Application for Variation of an Environmental Permit

Application No. : VEP-428/2014 (Date of Application: 27 January 2014)

North Development Office, Civil Engineering and Development Department

Environmental Permit No. EP-593/2021
環境許可證編號 EP-593/2021

Figure 3

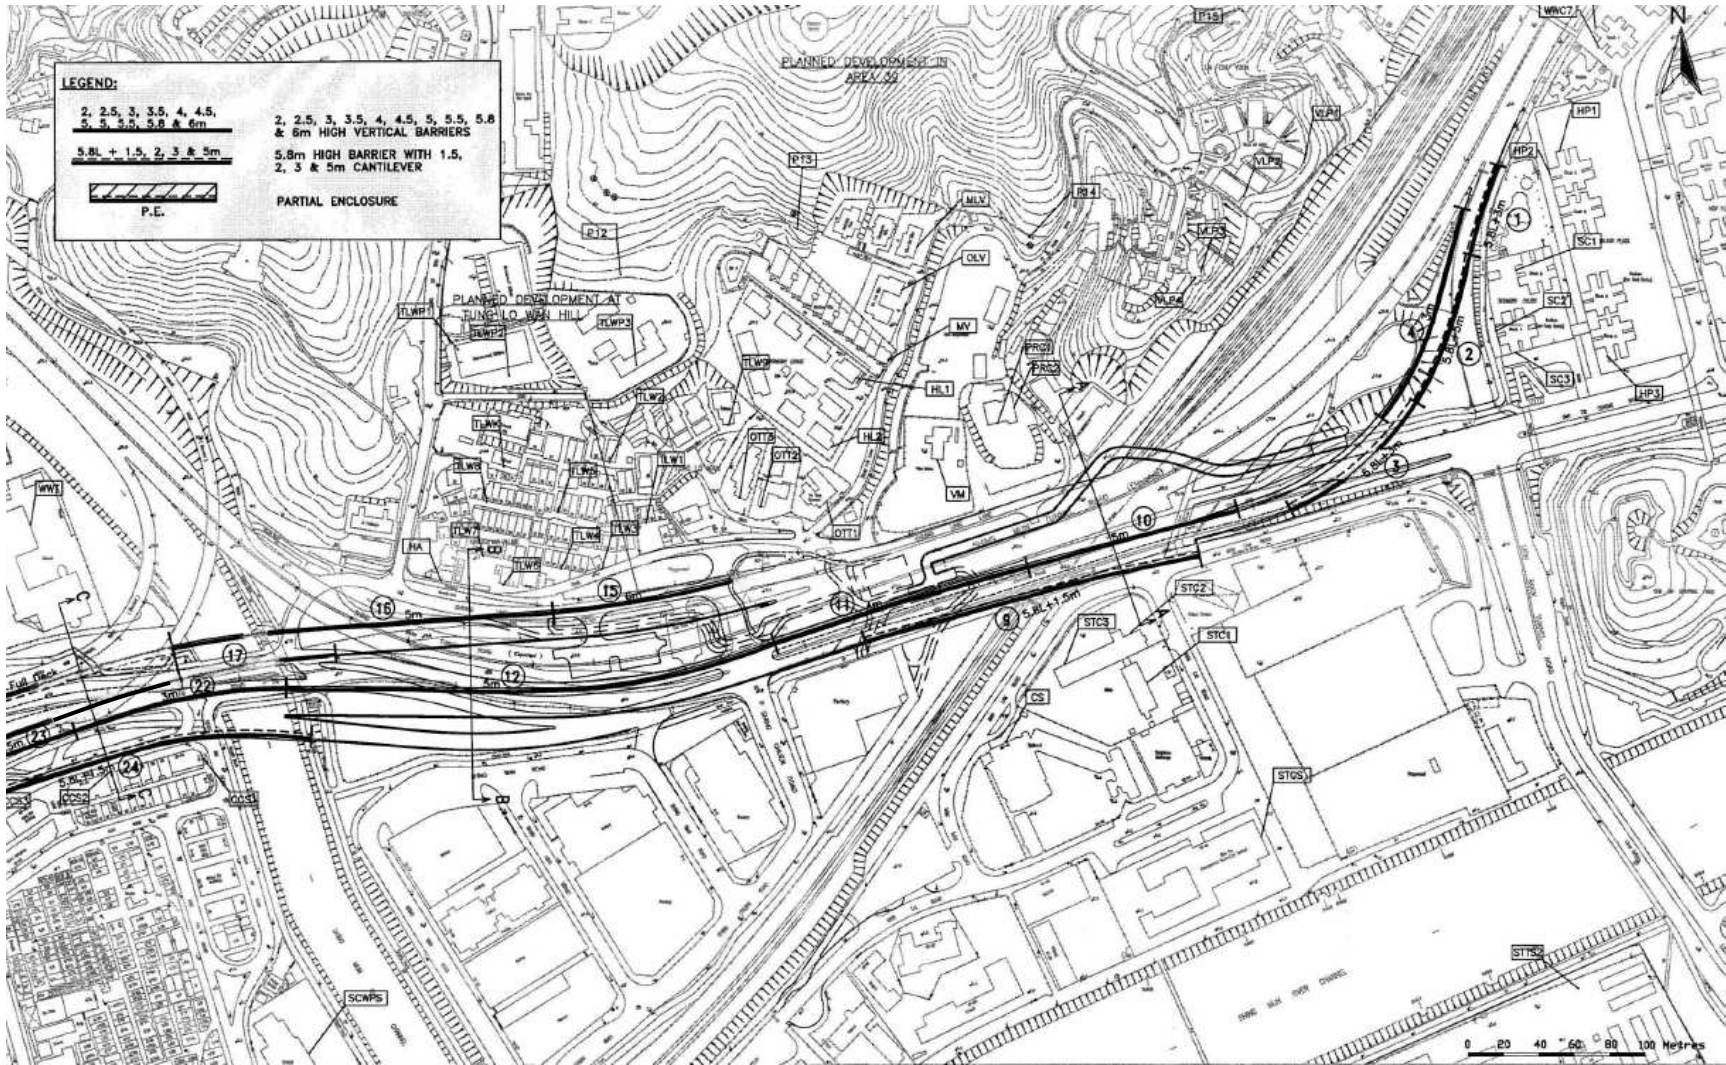
Mitigation Measures	Location
Low noise road surfacing (LNRS)	On Trunk Road T3 (see Figure 2)
A 5.8m high with 3m cantilever of approx. 55m long (see segment no. 1 in Figure 3), A 5.8m high with 5m cantilever of approx. 90m long (see segment no. 2 in Figure 3), A 5.8m high with 3m cantilever of approx. 75m long (see segment no. 3 in Figure 3), A 3m high vertical barrier of approx. 130m long (see segment no. 4 in Figure 3), and	near Hilton Plaza , Scenery Court and Vila le Parc
A 5.8m high with 1.5m cantilever of approx. 190m long (see segment no. 9 in Figure 3), and	near Sha Tin Clinic, Sha Tin Government School and Caritas School
A 5m high vertical barrier of approx. 120m long (see segment no. 10 in Figure 3), A 4m high vertical barrier of approx. 150m long (see segment no. 11 in Figure 3), A 5m high vertical barrier of approx. 275m long (see segment no. 12 in Figure 3), A 6m high vertical barrier of approx. 100m long (see segment no. 15 in Figure 3), and A 5m high vertical barrier of approx. 205m long (see segment no. 16 in Figure 3).	near Pine Ridge Church, Villa Maria, Man Lin Villa, On Ting Terrace and Tung Lo Wan Village

A 3m high vertical barrier of approx. 270m long (see segment no. 17 in Figure 3), A partial enclosure of approx. 180m long (see segment no. 18 in Figure 4), A 5.8m high with 5m cantilever of approx. 150m long (see segment no. 19 in Figure 4), A 5.8m high vertical barrier of approx. 15m long (see segment no. 20 in Figure 4), A 5.8m high with 5m cantilever of approx. 85m long (see segment no. 21 in Figure 4),	near Chik Chuen Street, Kam Shan Building, Sha Tin Public School and Mei Lam Estate

Figure 4

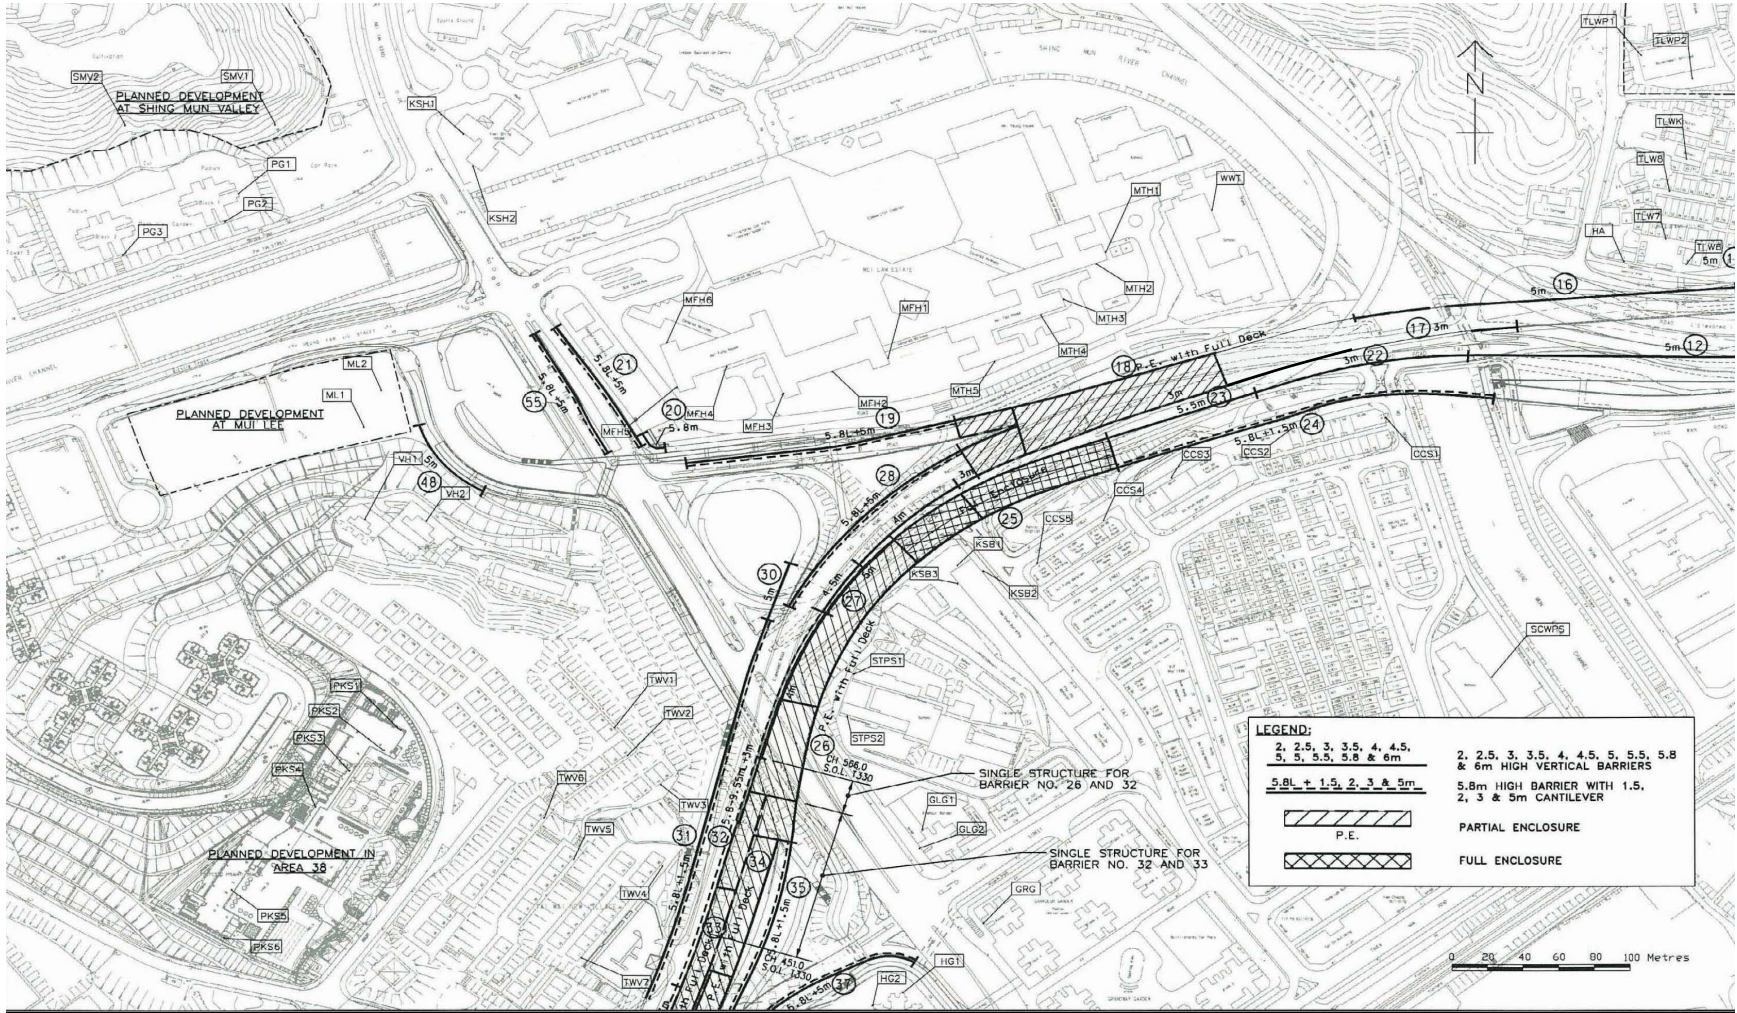
<p>A 3m high vertical barrier of approx. 120m long (see segment no. 22 in Figure 4),</p> <p>A 5.5m high vertical barrier of approx. 85m long (see segment no. 23 in Figure 4),</p> <p>A 5.8m high with 1.5m cantilever of approx. 215m long (see segment no. 24 in Figure 4),</p> <p>A full enclosure of approx. 130m long (see segment no. 25 in Figure 4),</p> <p>A partial enclosure of approx. 190m long (see segment no. 26 in Figures 4 and 15),</p> <p>A 5m high vertical barrier of approx. 75m long (see segment no. 27 in Figure 4), and</p> <p>A 5.8m high with 5m cantilever of approx. 145m long (see segment no. 28 in Figure 4).</p>	
<p>A 4m high vertical barrier of approx. 75m long (see segment no. 29 in Figure 4),</p> <p>A 4.5m high vertical barrier of approx. 50m long (see segment no. 54 in Figure 4).</p> <p>A 5.8m high with 4m cantilever of approx. 85m long (see segment no. 55 in Figure 4).</p>	<p>near Chik Chuen Street, Kam Shan Building, Sha Tin Public School and Mei Lam Estate</p>

<p>A 5m high vertical barrier of approx. 35m long (see segment no. 30 in Figure 4), and</p> <p>A 5.8m high with 1.5m cantilever of approx. 300m long (see segment no. 31 in Figures 4 and 12).</p> <p>A 4 m high vertical reflective barrier of approx 10m long (see segment no. 31a in Figures 5 and 12)</p> <p>A 3 m high vertical reflective barrier of approx. 5m long (see segment no. 31b in Figures 5 and 12)</p> <p>A 5.8m high with 1.5m cantilever of approx. 35m long (see segment no. 31c in Figures 5 and 12)</p> <p>A 5.8m high with 1.5m cantilever of approx. 50m long (see segment no. 31d in Figures 5 and 12)</p>	<p>near Tai Wai New Village</p>
<p>A 5.8m high with 3m cantilever of approx. 350m long (see segment no. 32 in Figures 4 and 15),</p>	<p>near Glamour Garden, Grandeur Garden, Holford Garden, Lau Pak Lok</p>

<p>A partial enclosure of approx. 295m long (see segment no. 33 in Figures 4, 5 and 15),</p> <p>A partial enclosure of approx. 125m long (see segment no. 34 in Figures 4 and 5),</p> <p>A 5.8m high with 1.5m cantilever of approx. 120m long (see segment no. 35 in Figures 4 and 5),</p> <p>A 5.5m high vertical barrier of approx. 75m long (see segment no. 36 in Figure 5), and</p> <p>A 5.8m high with 5m cantilever of approx. 115m long (see segment no. 37 in Figure 5).</p>	<p>Secondary School, Cheng Wing Gee College and planned development at Tai Wai Depot</p>
<p>A partial enclosure of approx. 50m long (see segment no. 38 in Figure 5),</p> <p>A 5.8m high with 5m cantilever of approx. 170m long, with the first 3.0m of this cantilever abutting the Underpass to be in the form of a vertical noise barrier type of 7.5m high. (see segment no. 39 in Figures 5 and 14),</p> <p>A 4m high vertical barrier of approx. 137m long (see segment no. 40 in Figures 5 and 7),</p> <p>A 3m high vertical barrier of approx. 50m long (see segment no. 41 in Figure 5),</p> <p>A 4m high vertical barrier of approx. 80m long (see segment no. 42 in Figure 5),</p> <p>A 5.8m high with 1.5m cantilever of approx. 70m long (see segment no. 52 in Figure 5), and</p> <p>A 5m high vertical barrier of approx. 35m long (see segment no. 53 in Figure 5).</p>	<p>near Glamour Garden, Grandeur Garden, Holford Garden, Lau Pak Lok Secondary School, Cheng Wing Gee College and planned development at Tai Wai Depot</p>

SHEET TITLE
 WORKS (MODIFICATION AND REPROVISION OF EXISTING NOISE MITIGATION MEASURES)

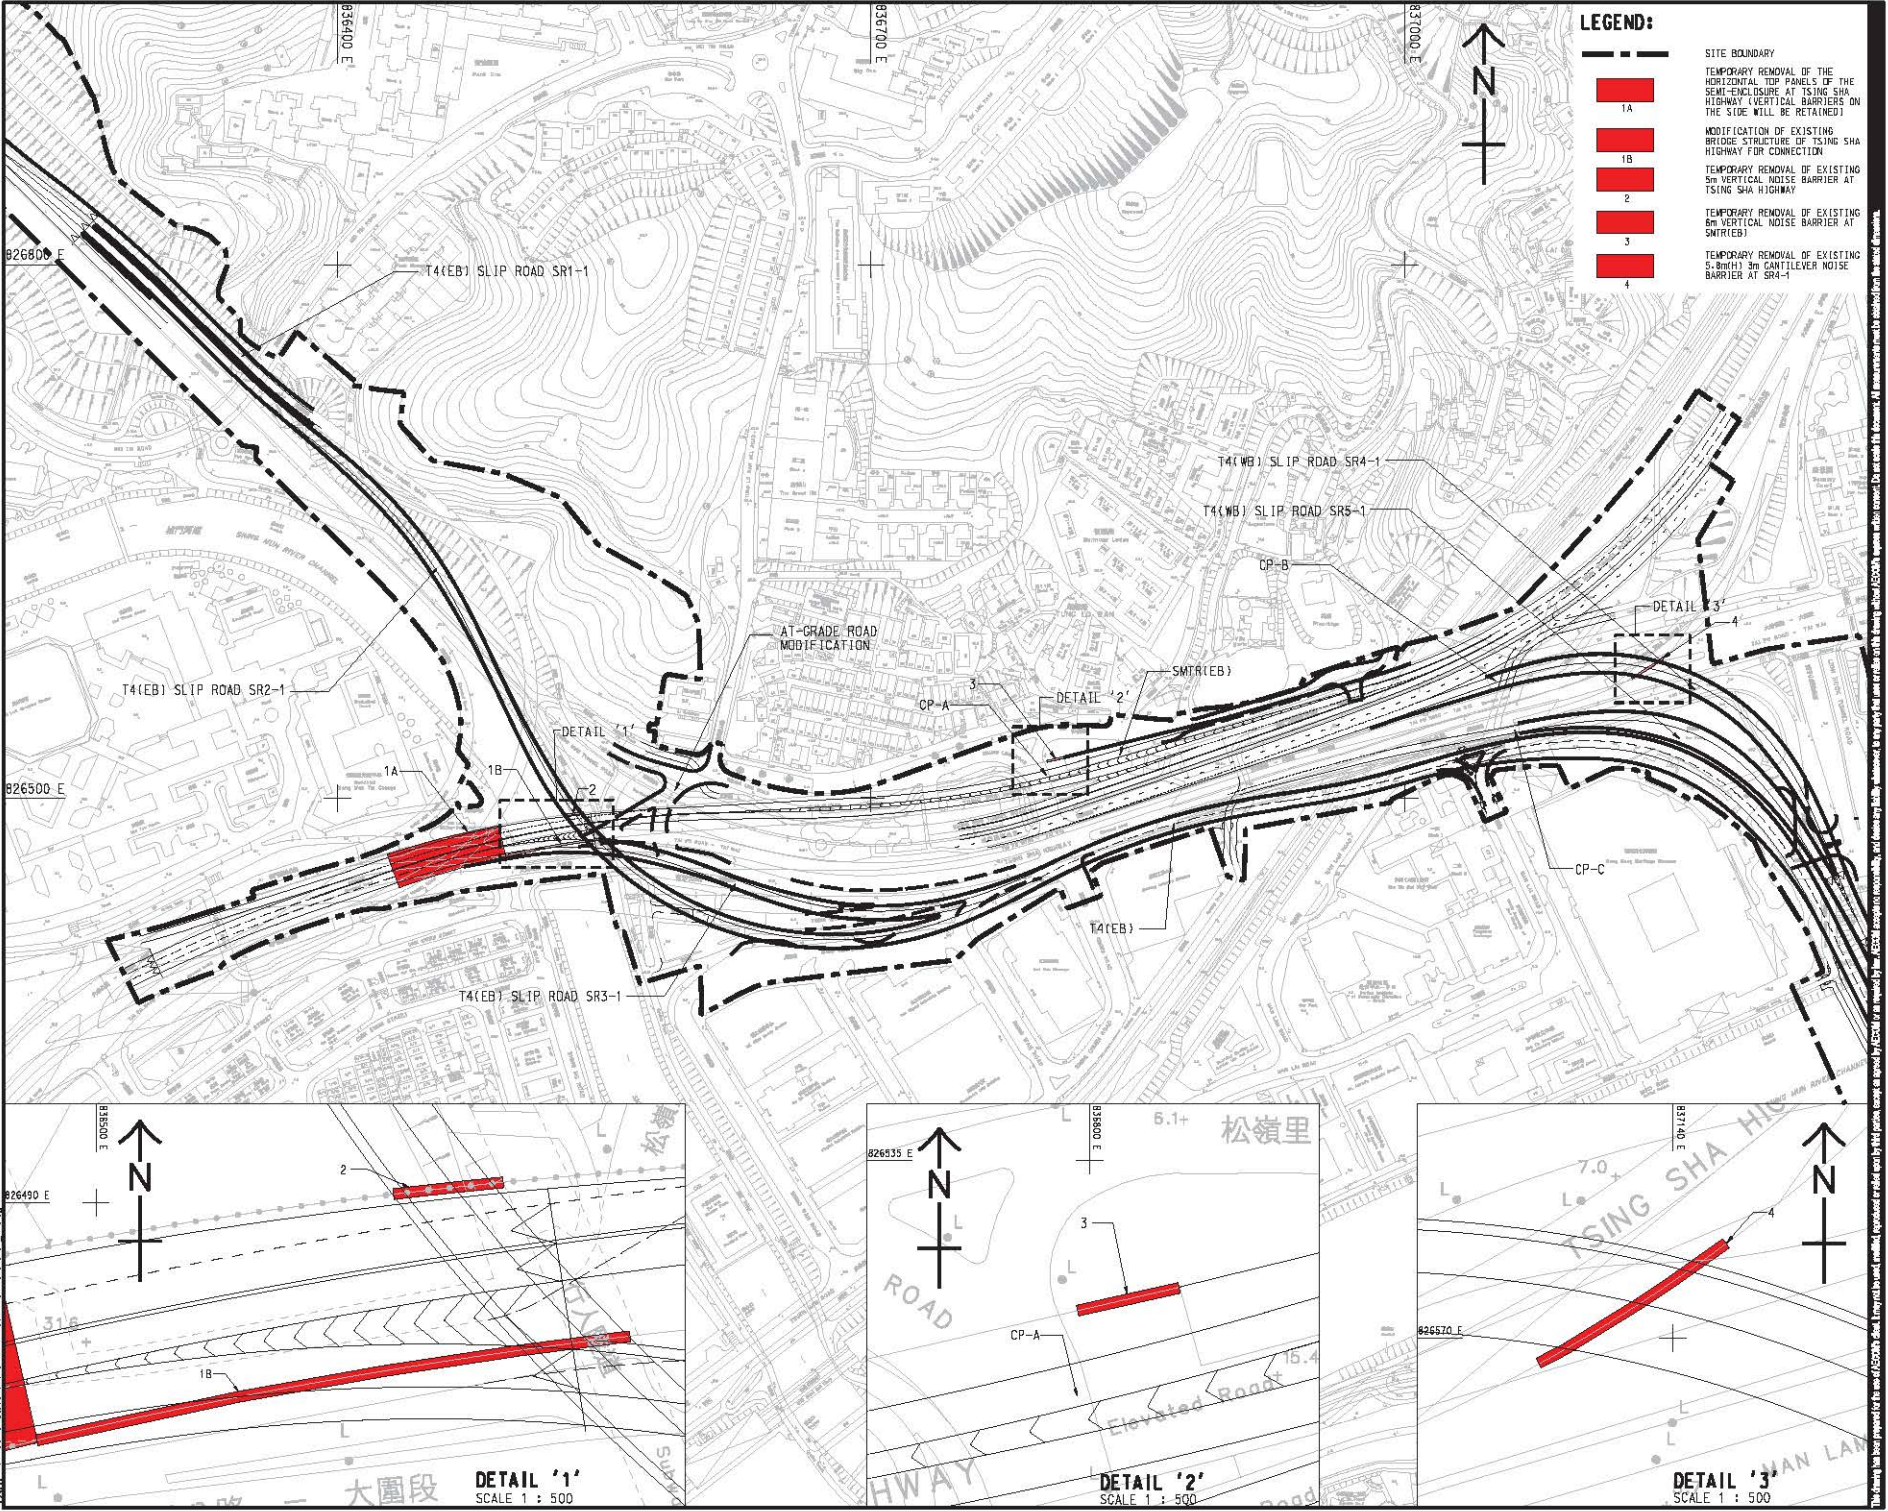
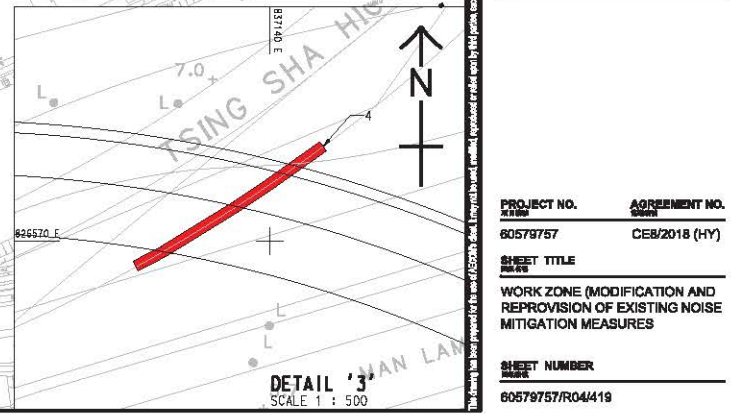
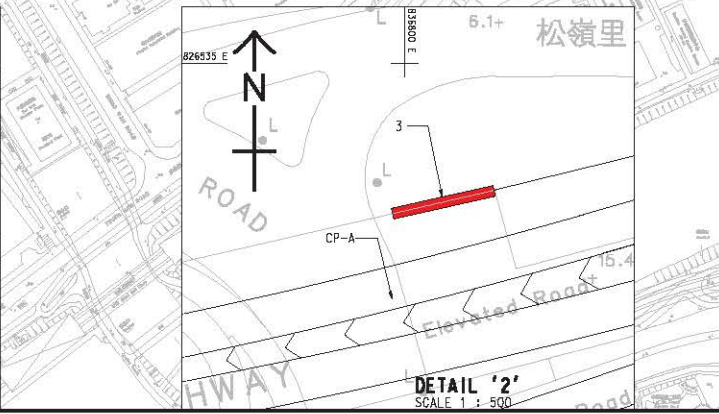
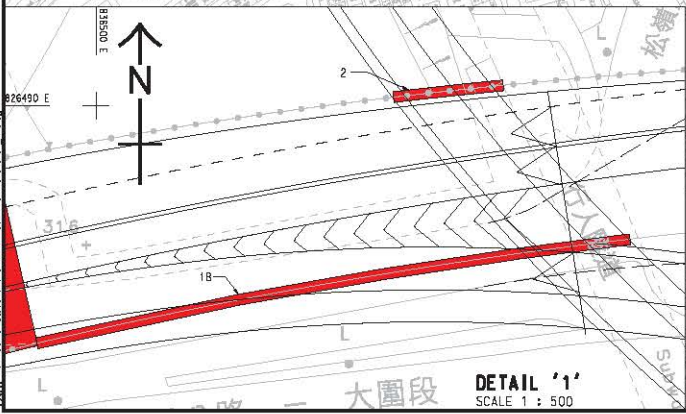
- 4.7.2.3 Referencing the Environmental Permit (EP) of Sha Tin New Town – Stage II, Trunk Road T3 (Tai Wai) (EP-135/2002/J), there are four locations (refer to works ID 1A, 2, 3 and 4 in 60579757/R04/419 of [Appendix 4.2](#) for location and **Table 4.7** below for details) where existing noise mitigation measure covered in the EP will need to be temporarily modified and reprovisioned due to proposed works for the Project. This is due to insufficient headroom for the construction of proposed slip road SR2-1, SR3-1, SR4-1 and insufficient works area for the proposed road widening works for Shing Mun Tunnel Road (SMTR) (EB) near reserved T4 connection point CP-A. There is one location (refer to Works ID 1B in **Table 4.7** for details) where existing noise mitigation measure covered in the EP will be permanently removed. This is due to conflict at location of connection of proposed slip road SR3-1 to Tsing Sha Highway with the existing noise mitigation measure.

Works ID	Location of Works	Existing Noise Mitigation Measures	Tentative Date for Modification/ Removal	Tentative Date for Reprovision	Approximate Extent, m	Duration without Measure, months
1A	Works Area A2	Semi-enclosure ^[1]	Sep 2026	Jan 2027 – Feb 2027	55m	6
1B	Works Area A2	3m Vertical Noise Barrier ^[2]	Oct 2026	Permanently removed for the construction of T4 (EB) Slip Road SR3-1	60m	N/A
2	Works Area A2	5m Vertical Noise Barrier ^[3]	Oct 2026	Feb 2027 – Mar 2027	10m	6
3	Works Area A3 (CP-A)	6m Vertical Noise Barrier ^[4]	Jun 2027 – Jul 2027	Sep 2027 – Nov 2027	5m	6
4	Works Area A3 (T4(WB) SR4-1)	5.8m (H) with 3m cantilever ^[5]	Nov 2026	Jan 2027 – Feb 2027	20m	4

TEMPORARY REMOVAL OF THE HORIZONTAL TOP PANELS OF THE SEMI-ENCLOSURE AT TSING SHA HIGHWAY VERTICAL BARRIERS ON THE SIDE WILL BE RETAINED

MODIFICATION OF EXISTING BRIDGE STRUCTURE OF TSING SHA HIGHWAY FOR CONNECTION

TEMPORARY REMOVAL OF EXISTING 5m VERTICAL NOISE BARRIER AT TSING SHA HIGHWAY

TEMPORARY REMOVAL OF EXISTING 8m VERTICAL NOISE BARRIER AT SMTR(EB)

TEMPORARY REMOVAL OF EXISTING 5.8m(19') 3m CANTILEVER NOISE BARRIER AT SR4-1
